TOLEDO - LUCAS COUNTY PLAN COMMISSIONS

REF: SUP24-0005

DATE: January 17, 2025

Request for a Special Use Permit for a Used Auto Sales Lot at 5655 Secor Road.

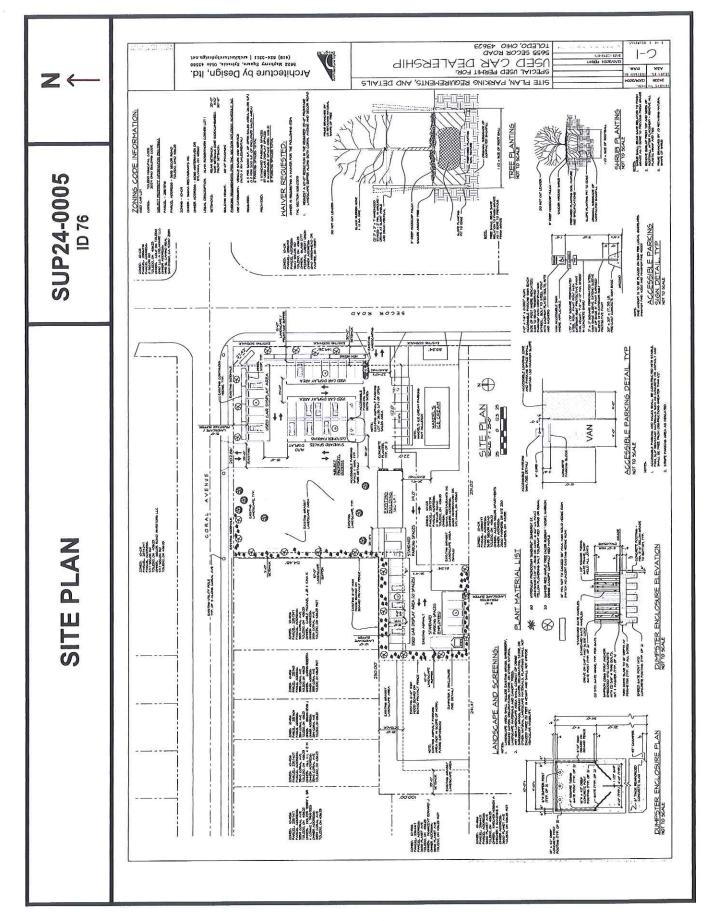
The site plan submitted depicts an "existing asphalt parking area" for future expansion in the southwest area of the parcel. The area for proposed future expansion shall not be used for storage or parking of vehicles. Any future modifications or use of this area shall be subject to review for an amendment to the Special Use Permit.

In pursuant to TMC§1107.1303, sidewalks in commercial districts shall be constructed along all public streets. Per the site plan sidewalk exists surrounding the lot along the public roads. However, sidewalk is not existing at the north west area along Coral Avenue. Sidewalk shall be installed to complete connectivity, conform to this section of the code, and is listed as a condition of approval. This site has a shared access easement for the driveway accesses with the adjacent drive-thru business to the south; north from Coral Avenue and east from Secor Road. As a condition of approval, the stacking spaces for Handel's ice cream parlor shall only be permitted within the shared access easement areas as depicted on the Final Plat.

- c. The south western location of the site where parking lot is abutting residential districts requires a continuous evergreen hedge (minimum 18" in height when installed) in the Type "A" buffer in lieu of individual shrubs; Not acceptable as depicted

- d. Parking lot interior and perimeter landscaping is required. For every parking space provided twenty square feet (20') of landscaping is required. A total 1,020 sq feet of interior parking lot landscaping shall be provided. A peninsula landscape area that replicates or mimics the existing peninsula landscape area at the eastern (Secor Road) driveway entrance, is required at the northern (Coral Avenue) entrance. A total of ten (10) trees and thirty (30) shrubs are required within the interior parking lot landscaping. Trees and shrubs that do not fit in peninsula landscape areas may be planted along the western perimeter of the parking lot perpendicular to Coral Avenue (north of the sales building) and count towards the interior parking lot landscaping requirements. Not acceptable. A revised landscaping plan shall be submitted.

- e. One (1) two-inch (2") caliper tree for every one-thousand square foot (1,000 sq. ft.) of building coverage is required. Acceptable as depicted.
- f. Foundation plantings are required along all portions of the building that are visible from the public right-of-way, and landscaping at all major building entrances. Foundation plantings are required. Not acceptable. A revised landscaping plan shall be submitted depicting foundation plantings along the northern portion of the of the sales building parallel to Carol Avenue.

- p. The location, number, height, diameter and species of any materials to be planted and maintained, as well as the location and number of any existing trees to be retained, trees, shrubs, and landscaped materials shall meet the standards of TMC§1108.0400 Landscape Material Standards. Not acceptable, a revised landscaping plan shall be submitted.

- Removed by 7. Sidewalk shall be installed along Coral Avenue in accordance with TMC§1107.1303.

- a. A minimum fifteen-foot (15') wide frontage greenbelt along all public streets is required. Frontage greenbelt shall include one (1) tree per every (30') of frontage, and a continuous shrub (minimum installation height of 18"). A total of eight (8) trees along Coral Avenue and six (6) trees along Secor Road are required; Not acceptable. A revised landscaping plan shall be submitted depicting the additional two (2) trees along Secor Road.
